645-018-12

ADDENDUM NO. 1

PROPOSAL FOR CONTRACT FOR
Rice Alley Replacement Project
Wayne State College
Wayne, Nebraska

Wayne State College; Rice Alley Replacement
Wayne, Nebraska
TCEP Project No.: 645-018-12

Addendum #01
Supplemental Drawing: SDL-001
Revision of Sheet: L1.01
Date: July 11, 2012

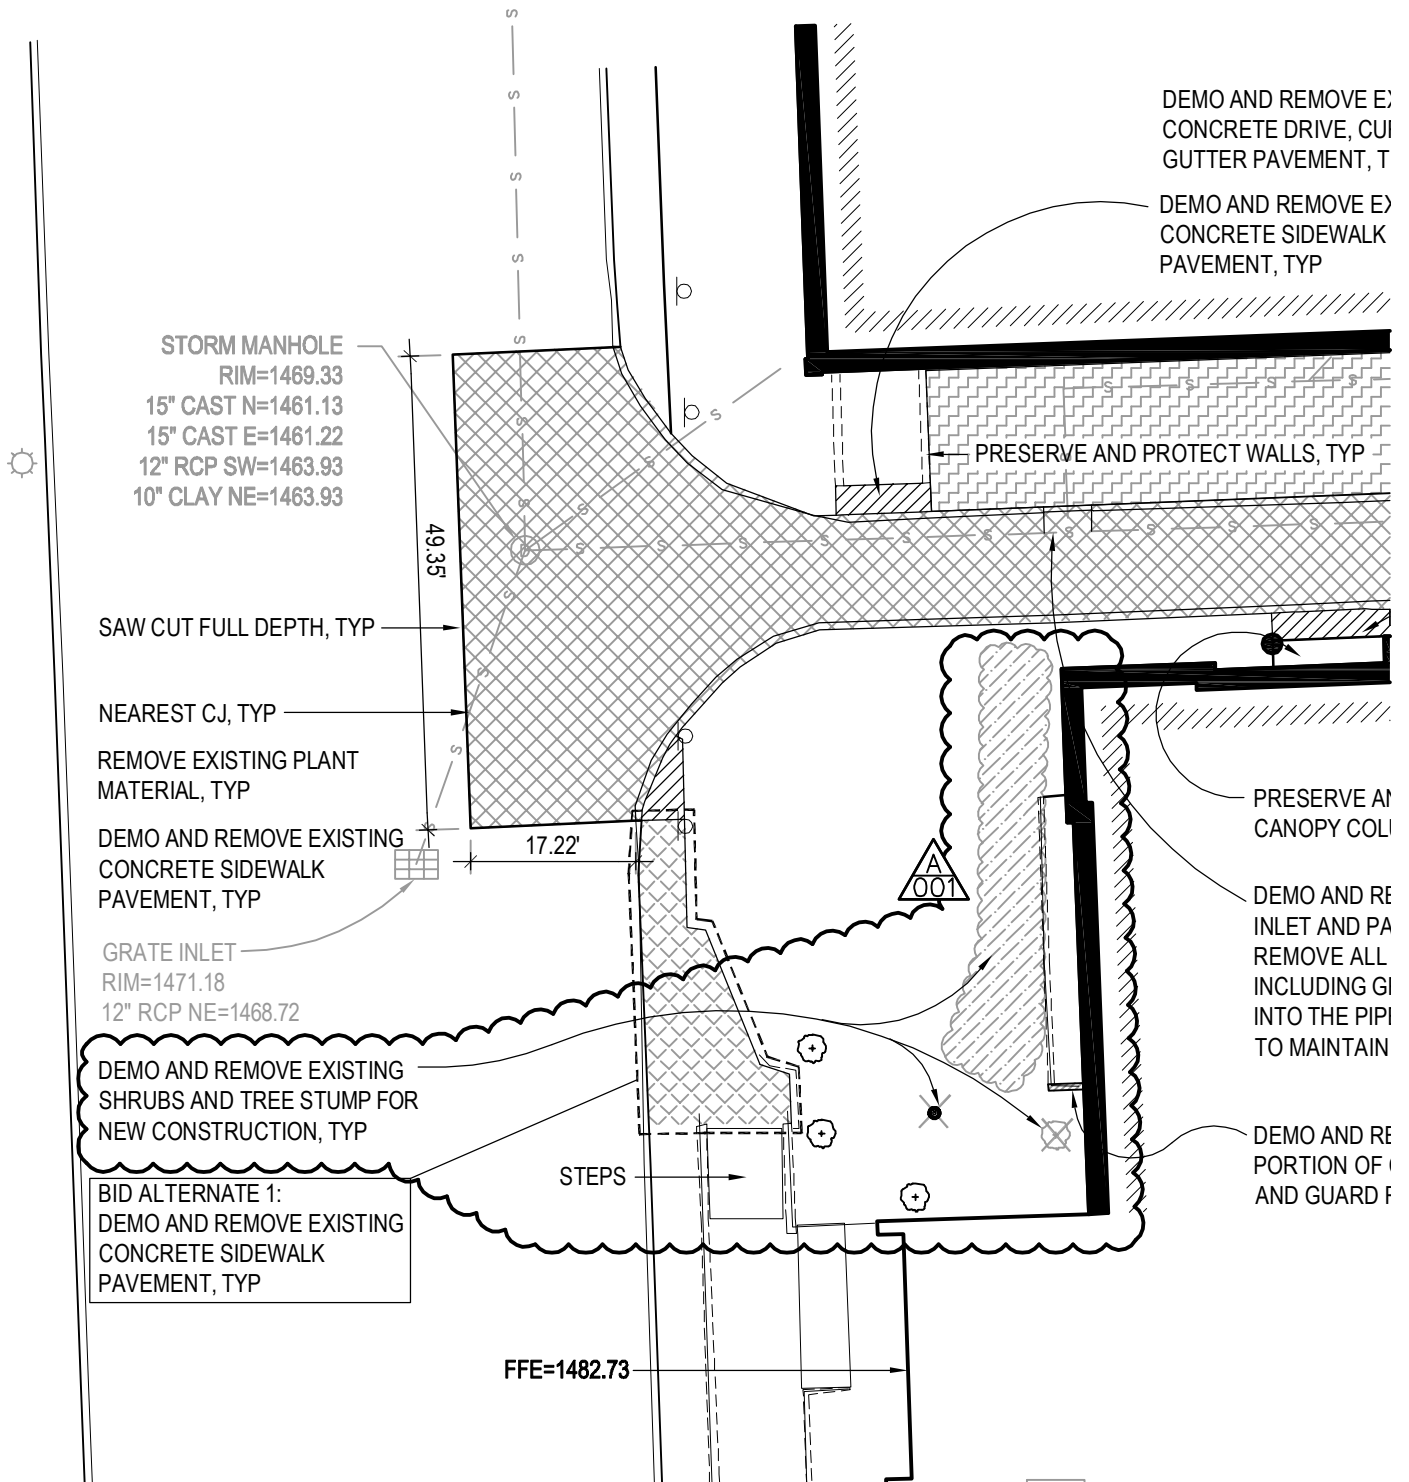
Q: Can all the shrubs in front of the wall be removed for equipment access?

A: Yes, see revised demolition plan.

Reference SDL-001 for removal of additional plant material as part of base bid.

Revise title of drawing to read "Existing Conditions / Site Demolition Plan"

Add note to Existing Conditions / Site Demolition Plan: "Remove and replace existing handicap signs as needed for new construction, typ."

Add note to Site Layout Plan "Restripe any parking lot lines that may have been removed as part of the new pavement construction, typ."

Addendum #01
 Supplemental Drawing: SDL-002
 Revision of Sheet: L1.02
 Date: July 11, 2012

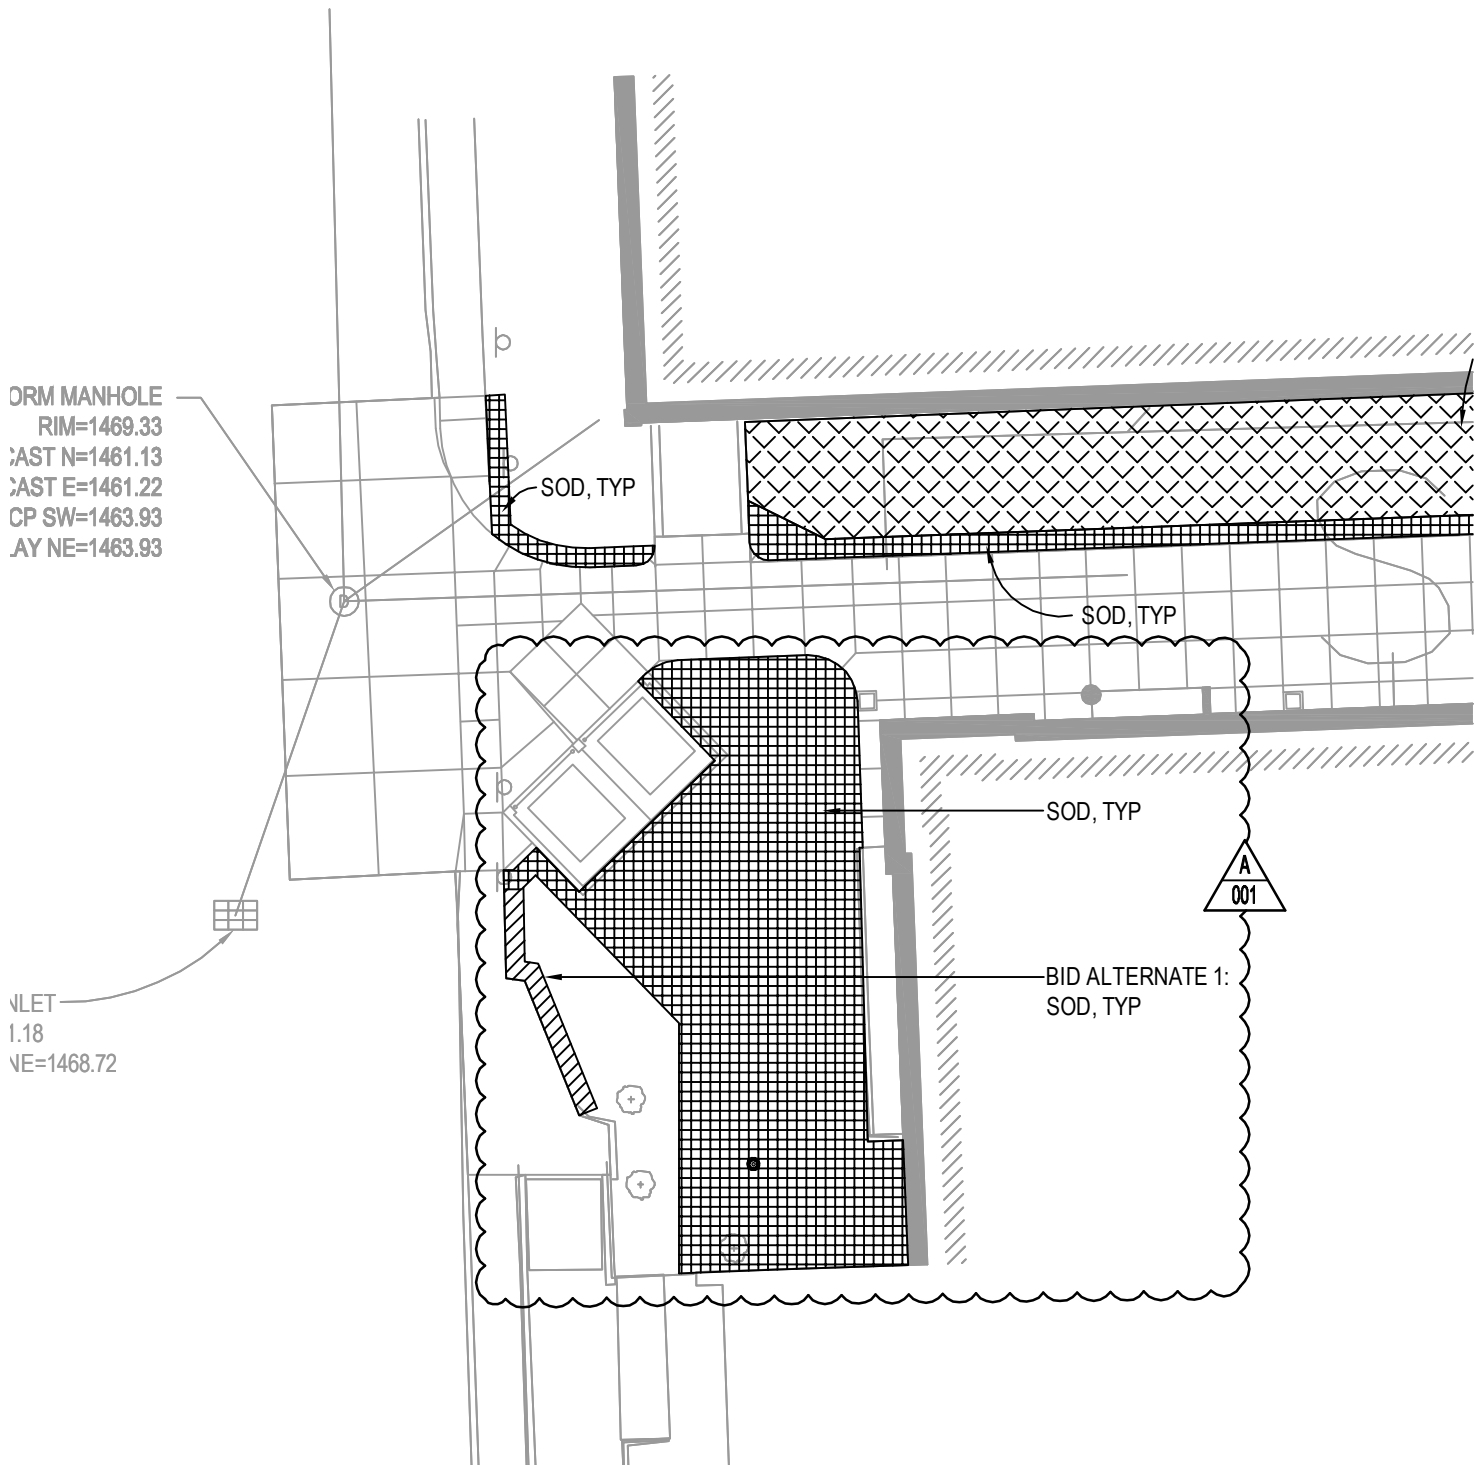
Reference SDL-002 for revised turf grass layout.

Add the following note to details 1-6. "In lieu of placing concrete on prepared subgrade, contractor may provide a two inch max leveling course of granular material (crushed concrete fines is acceptable) under all paving, typ."

Revise Detail 7 note to apply a "non-slip Broom finish".
